Ref: Non Material Amendments

Project: River Cottage, Church Street, Wargrave, Wokingham, RG10 8EP

Further to the Non-Material Amendment drawings submitted as part of this application, please find below an explanation of the proposed alterations.

Changes - Ch-02, Ch-09, Ch-15 (Fenestration amendment)

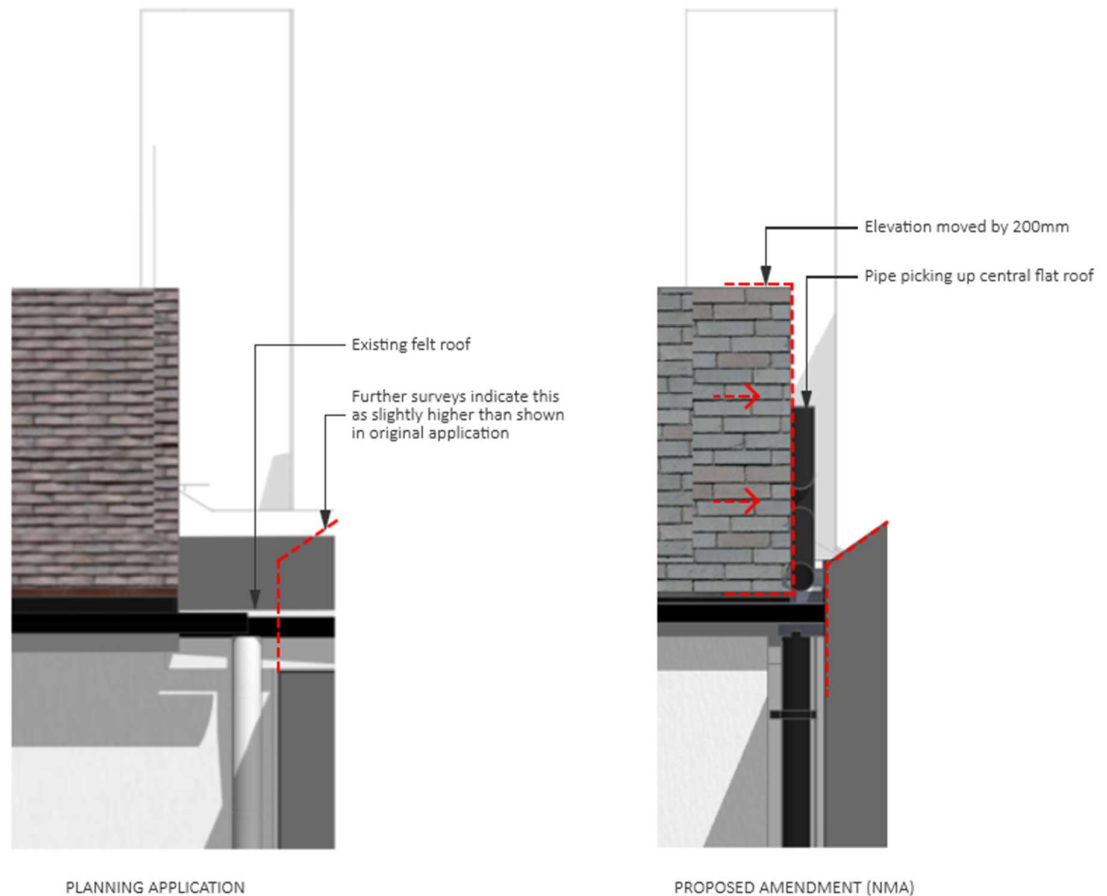
For change 02, the window has been relocated in response to internal layout adjustments and the revised position of the shower room. For change 09, we propose to change the existing single door to a double door arrangement of the same height and aspects. For change 15, we propose an additional roof light of the same proportions as the approved roof light.

Changes - Ch-05, Ch-06 and Ch-07 (clarity of detail):

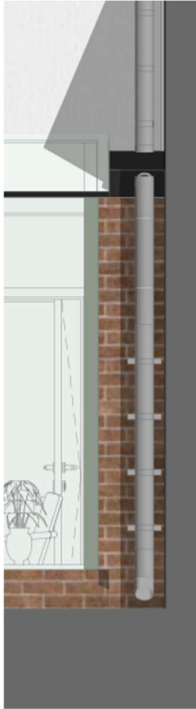
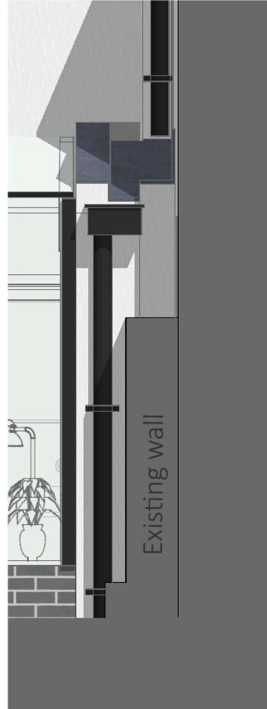
We propose to adjust the wall to a rendered finish and introduce a parapet for the glass roof to abut.

Changes - Ch-08 (clarity of detail)

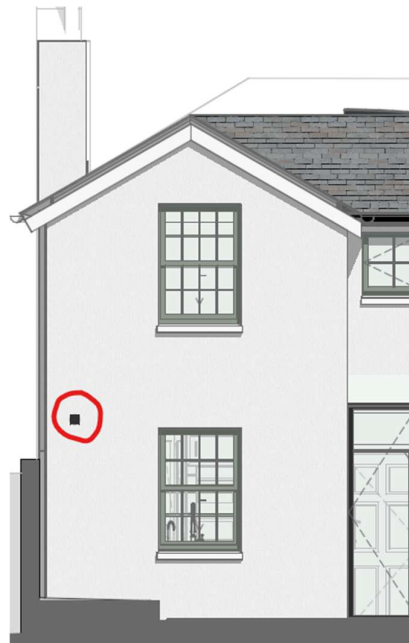
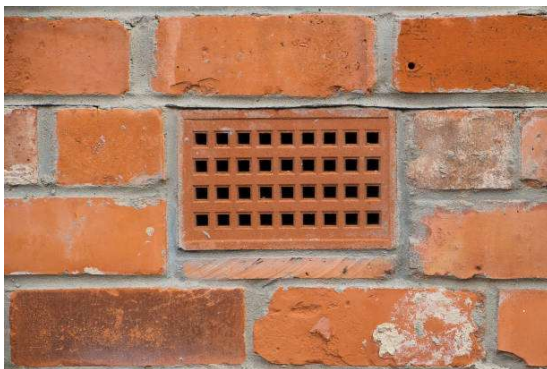
There is an existing extractor located to the rear of the gable end. We proposed to retain the location of this extractor vent in the new double storey extension but change it from a modern vent to a terracotta brick vent which will be painted white to match the colour of the proposed render.

(Existing extraction vent highlighted in red)

(Proposed extraction vent indicated in red)

(Proposed terracota brick vent to be painted white in keeping with render colour)

Changes - Ch-10, Ch-11, Ch-16 (structural design)

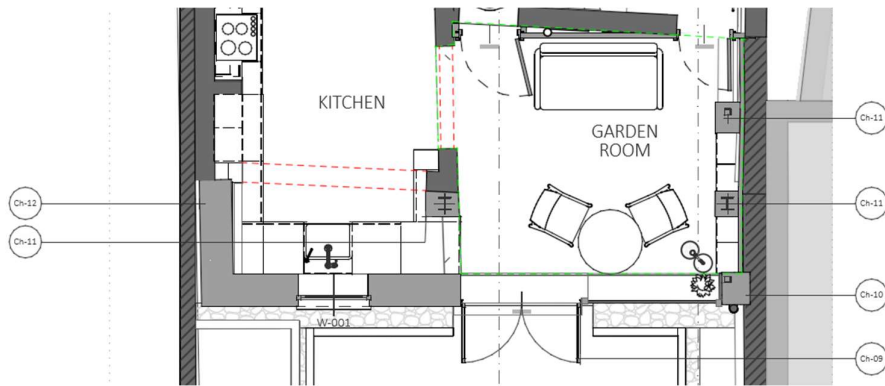
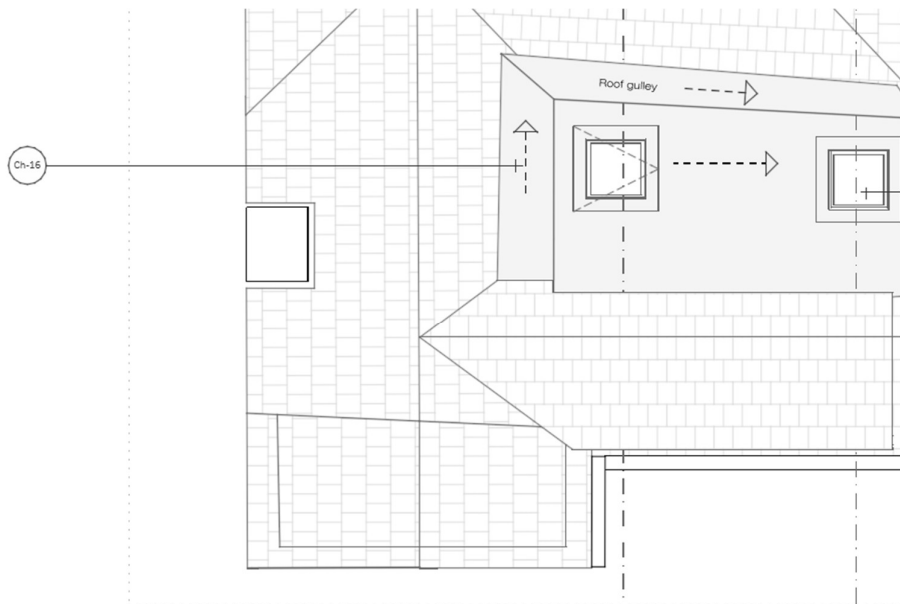
A structural design has now been completed, resulting at ground floor level the introduction of internal structural columns in leu of the proposed new internal wall shown on the original planning application. These allow the rear single-storey and double-storey extensions to be constructed with minimal impact on the existing walls.

The proposed rear flat roof abutting the existing rear gable has been reduced in size to reduce the load is carried by the existing elements:

Changes - Ch-12, Ch-13 (Abutment detail)

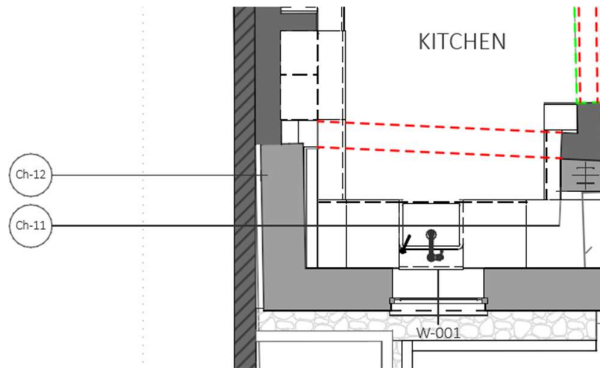
To the double-storey extension, the side abutting the existing garden wall to be set back slightly to allow for the undulation in the existing walls and it is at a slight slant.

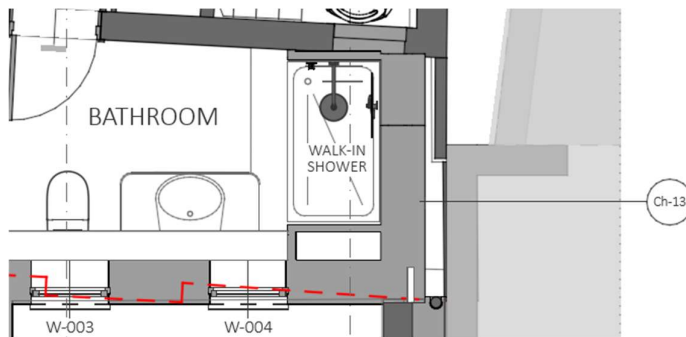
To the rear of the new (replacement) extension, at high level, we are proposing to construct a new independent side elevation wall, rather than installing a new insulated lining against the party wall belonging to Sister's Cottage.
